PLAN COMMISSION STAFF REPORT

AUGUST 20, 2015

SPEEDWAY

SUBSTANTIAL DEVIATION OF TINLEY CROSSINGS CORPORATE CENTER PLANNED UNIT DEVELOPMENT, REZONING, SITE PLAN REVIEW, PLAT APPROVAL

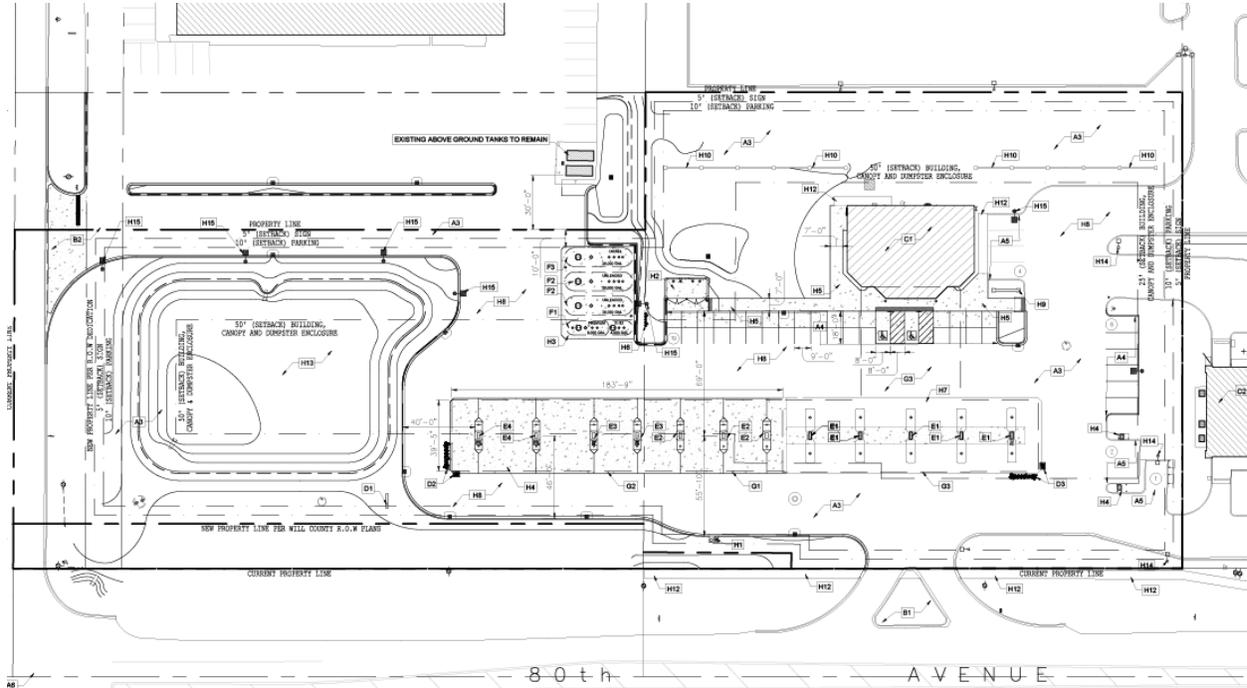
Traditionally an overlay district supersedes the underlying zoning district; however the Urban Design Overlay District is silent with respect to lot area and depth. The UDO District does however restrict the front yard setback to a maximum of 20 feet. The setback of the expanded canopy is somewhat limited by the location of the existing canopy which has a 54’ setback from 80th Avenue. A point of note is that with the future widening of 80th Avenue, additional right-of-way will be taken from this property which will reduce the front yard setback to 25’ on Parcel 1 and 44’ on a portion of Parcel 2. As part of the PUD, this increase in proposed setback is considered an exception to the PUD rather than a variance. This exception has also been noted in bold in the table above.

The requested rezoning for Parcel 1 to M-1 upon annexation, is consistent with the zoning of the adjacent parcels and the Tinley Crossings Corporate Center PUD. It provides consistent zoning and landuse along the west side of 80th Avenue from 183rd to 185th; it was also part of the zoning/landuse contemplated with the original PUD approval for this area. The annexation of Parcel 1 and the expansion of the fueling dispensers provides for an additional point of access (185th) and extension of the sidewalk along 80th Avenue which is consistent with the goals of the Urban Overlay District to accommodate pedestrian access.

Open Item #2: The proposed improvements do not meet lot area, lot depth and front yard setback requirements of the M-1 and Urban Design Overlay District.

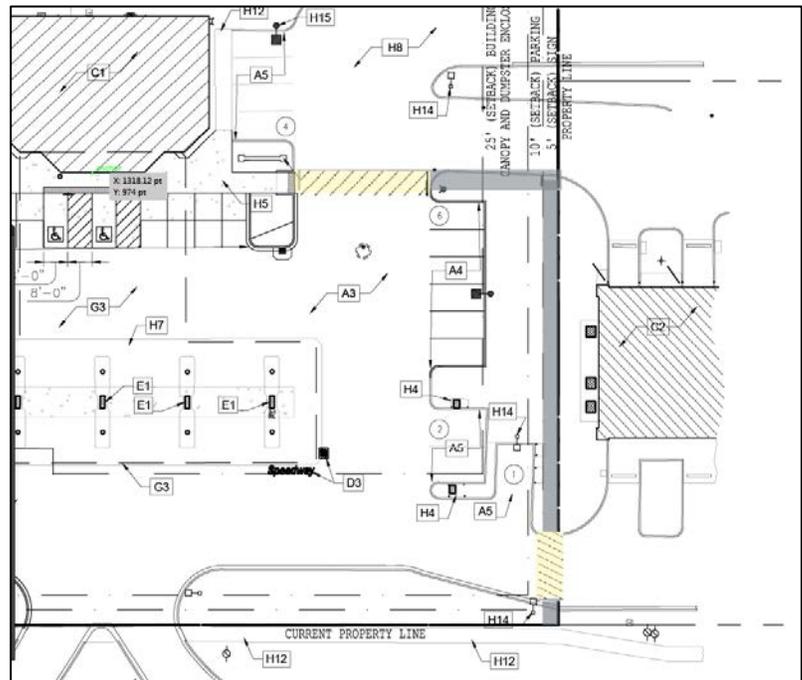
The Urban Overlay District requires each site to “provide opportunities for the public to bike, walk, drive, or take public transportation to, among, and within the development while minimizing the conflicts between these methods.” A sidewalk exists along the 80th Avenue frontage of Parcels 2 & 3.

This sidewalk will need to be extended across the 80th Avenue and 185th Street frontages of Parcel 1. Due to the future widening of 80th Avenue staff recommends cash-in-lieu of payment be made for the extension of the sidewalk along 80th Avenue and along 185th Street.

Consideration should also be made for pedestrian access from the sidewalk along 80th Avenue to the station. Staff has recommended a pedestrian path in the diagram which would include striping a crosswalk across two access ways.

Open Item #3: A 6' sidewalk along 80th Avenue and 185th Street will be required; Staff recommends cash-in-lieu payment. The Overlay District requires opportunities for pedestrian and bicycle access. Provide access from the sidewalk on 80th Avenue to the site. Bike racks are encouraged.

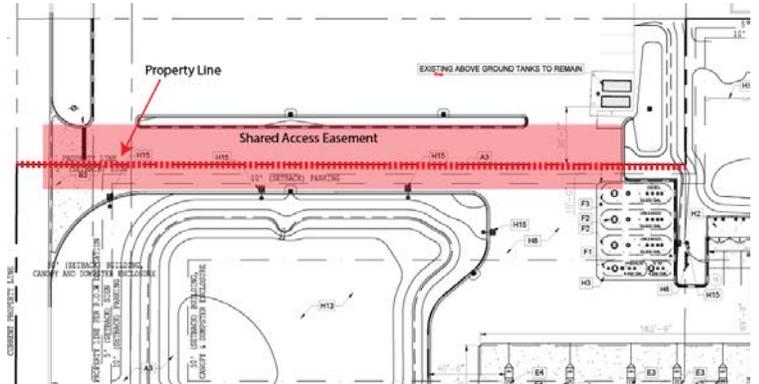
With the annexation of Parcel 1, another point of access is provided for the subject property at 185th Street. The plans indicate that the parcel west of the annexed parcel will then close their existing point of access and create a shared access with Parcel 1. The appropriate easement will need to be recorded with the plat indicating a cross access easement.

Open Item #4: Cross access easement is not provided on the proposed Plat of Subdivision.

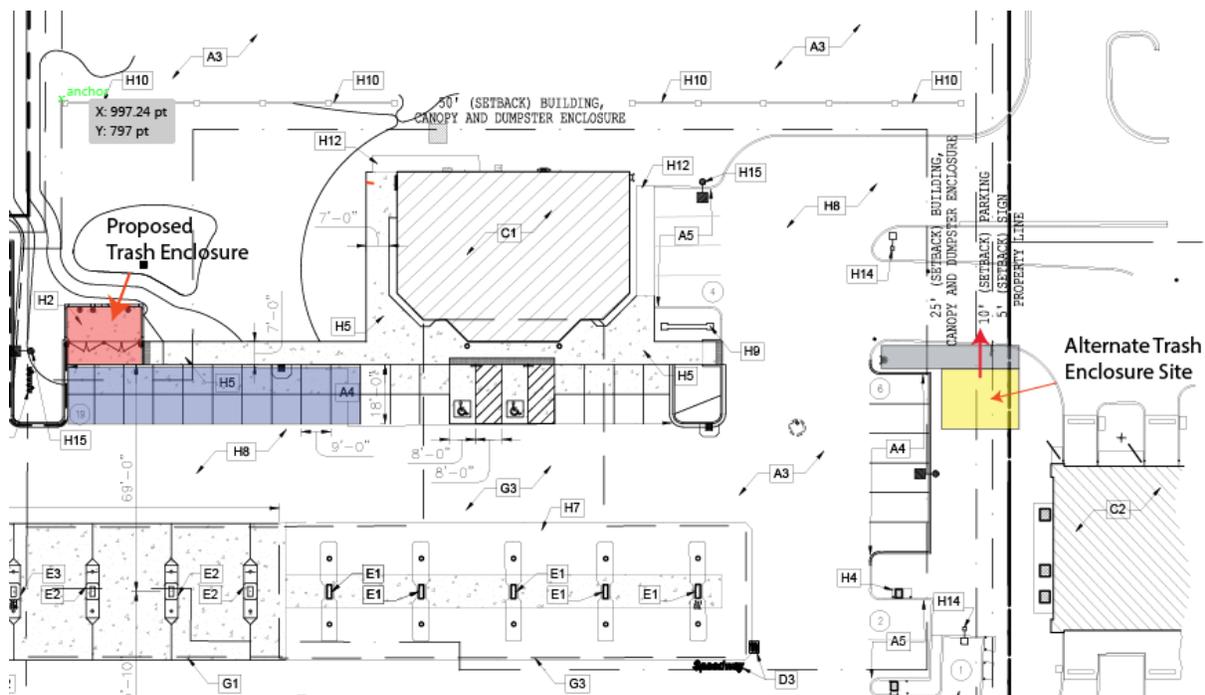
The current provision of 21 parking spaces meets ordinance requirements for the 3,100 square foot C-Store. Since there is no expansion or change of use proposed for the C-Store, no additional parking is required. The Applicant has stated that due to congestion experienced at the current facility they have planned for an additional 10 parking spaces for a total of 31 parking spaces. The proposed parking is aligned along the front of the convenience store. The south side of the C-Store has been revised to accommodate the additional parking as well as the area south of the carwash. The paved area south of the C-store will be removed (shaded in green) and is proposed to be landscaped. The trash enclosure will be located at the south end of the new proposed line of parking.

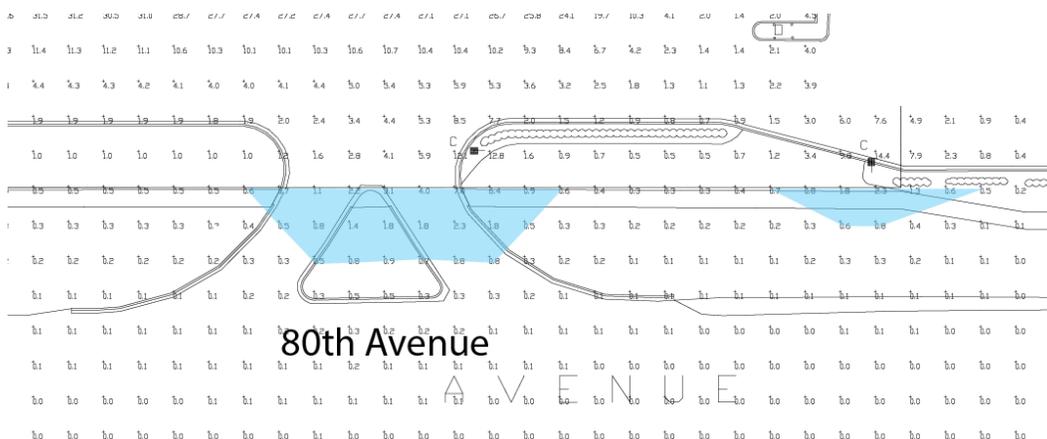
Staff has expressed concern regarding the proposed location of the trash enclosure. The Applicant has located it in a highly visible location with parking spaces directly in front of the gates that may compromise collection operations. During several site visits to the facility, staff found the gate open and the trash enclosure exposed. The gates are actually propped open as seen in the photograph.

Staff believes there are other locations that may be less conspicuous and unsightly to the general public. One recommendation is provided in yellow in the diagram above.

Open Item #5: The proposed location for the trash enclosure presents operational issues and is highly visible to the public.

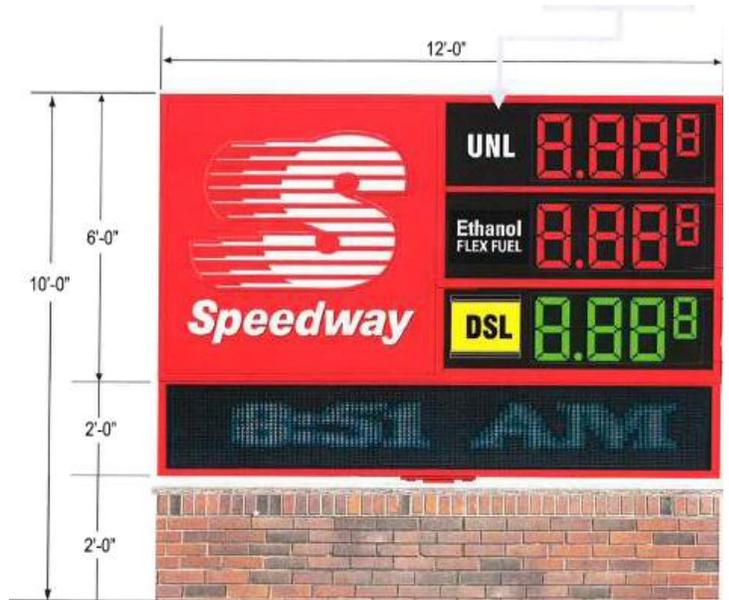
The proposed plan indicates the removal of the existing ground mounted sign along 80th Avenue. The Applicant has requested a new ground mounted sign to be located further south on the 80th Avenue frontage. The new sign proposes an electronic message band in addition to an electronic gas price sign. Electronic gas price signs are permitted in the Sign Regulations; however they are limited to twenty (20) square feet in area. The Ordinance is unclear as to whether this is per sign face or if it is a total sign area limitation. The proposed plan is not sufficiently labeled to determine the sign area for the gas prices.

The electronic message board on this ground mounted is also permitted per Ordinance however it is limited to no more than 20% of the total single elevation area of the monument sign. The

proposed electronic message band represents 25% of the total single elevation area of this sign. The Applicant has been informed that if they elect to use an electronic message sign then no other type of temporary signage, including, but not limited to, "For Sale", "For Rent", or "For Lease" signs are allowed. Currently there is a considerable amount of temporary signage on the property as evidenced in the photos below.

There are two (2) other ground mounted signs on the property that include manually changeable message signs. These types of signs are prohibited per the Village Zoning Ordinance (Ordinance 2007-0-024, adopted April 17, 2007). When the ordinance was adopted, existing manually changeable signs were given three (3) years from the day of adoption to be removed or property owners were allowed to replace them with electronic message signs.

If the property owner elected to replace them with electronic message signs they are restricted to the 20% limit and the removal of all temporary signs as outlined above. The Applicant has not provided dimensioned plans for the new electronic message signs. In addition, per Village policy only one ground mounted sign is allowed per right-of-way frontage. There are a total of three (3) ground mounted signs on the property. The property's location on the corner may support two (2) signs, but staff encourages discussion of maintaining three (3) ground mounted signs.

Open Item #6: The proposed plans indicate signs that exceed Village regulations.
